Staff Report

Date: December 21, 2025
To: Devens Enterprise Commission
From: Neil Angus, FAICP, DEC Director,
RE: CFS-4 – 111 Hospital Road Site Plan Amendment Level 2 Unified Permit

Applicant/ Owner: Commonwealth Fusion Systems, LLC (CFS)
Engineer: VHB Engineering
Location: 111 Hospital Road, Devens, MA
Zoning: Innovation & Technology Business District, Watershed & Aquifer Water Resources Protection Overlay District

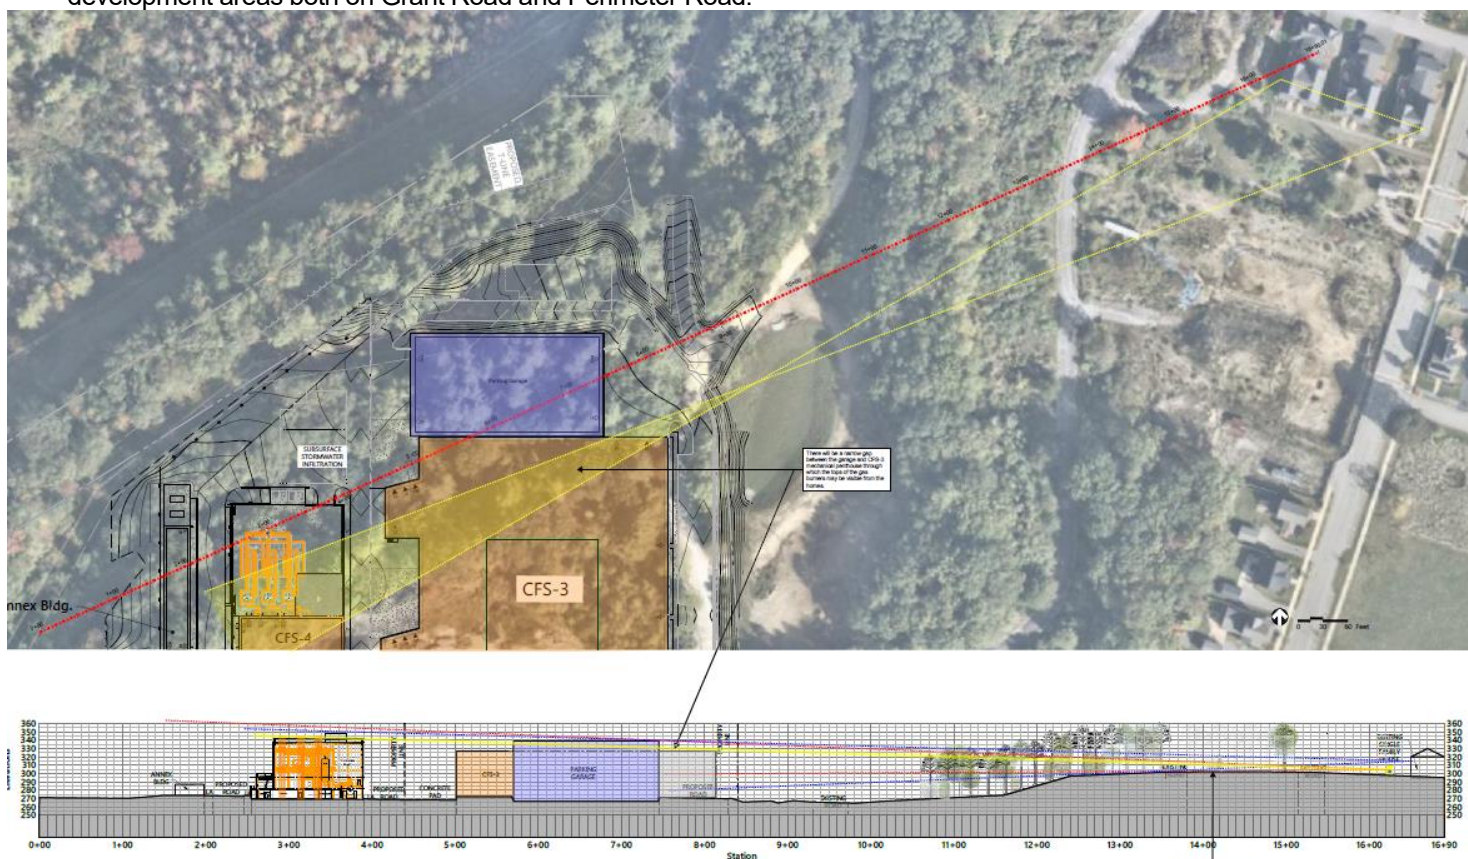
The Applicant has conducted Air Dispersion Modeling indicating that the project will not result in any exceedances of the National Ambient Air Quality Standards. In addition, the Applicant indicates that this project meets the requirements to complete a Cumulative Impact Analysis (CIA). The CIA is required because the potential project emissions require a Comprehensive Air Permit and the project is located within 1 mile of an Environmental Justice Area in the Devens Regional Enterprise Zone within the historic boundaries of Ayer, MA. CFS and their air quality consultant have been working closely with MassDEP to ensure the application meets all requirements. While the emissions will be intermittent, the Applicant should explore the feasibility of carbon capture and any other options that would reduce the level of emissions from these processes. Because the process is using air cooling vs. water cooling, there should be no visible emissions from the stack or other equipment. The Applicant should confirm that this will be the case year-round. CFS does not expect any odors or dust emissions when the system is operational. During construction, the contractor will take measures to minimize construction noise and dust

Sound Study: The Applicant submitted an initial sound study that only included the CFS-4 facility. DEC Peer review consultants have requested that the study include the entire campus as we need to review the cumulative impacts of sound from all existing and proposed sound sources. The Applicant submitted a revised sound study on November 19, 2025 that included CFS-4, as well as the proposed CFS-3 project, but did not factor in CFS-1 and 2 existing sound sources. As we await the submission of the full study, our consultants will review the CFS-3 and 4 modelling for input accuracy.
